Title of Change:	Remove blue band mark for QEB373 series
Effective date:	09 Jun 2024
Contact information:	Contact your local onsemi Sales Office or Esther.Lau@onsemi.com
Type of notification:	This Product Bulletin is for notification purposes only. onsemi will proceed with implementation of this change upon publication of this Product Bulletin.
Change Category:	Remove blue band mark for QEB373 series
Change Sub-Category(s):	Remove blue band mark for QEB373 series

Pin orientation as indicated in datasheet:

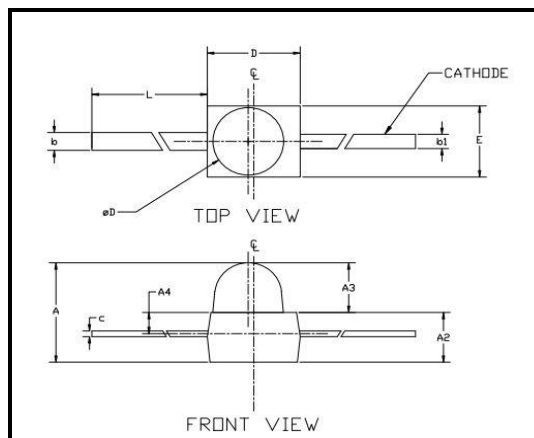
This Product Bulletin documents the removal of the blue marking at cathode side at the bottom of QEB373 series T-3/4 package. Pin orientation is already indicated in the datasheet.
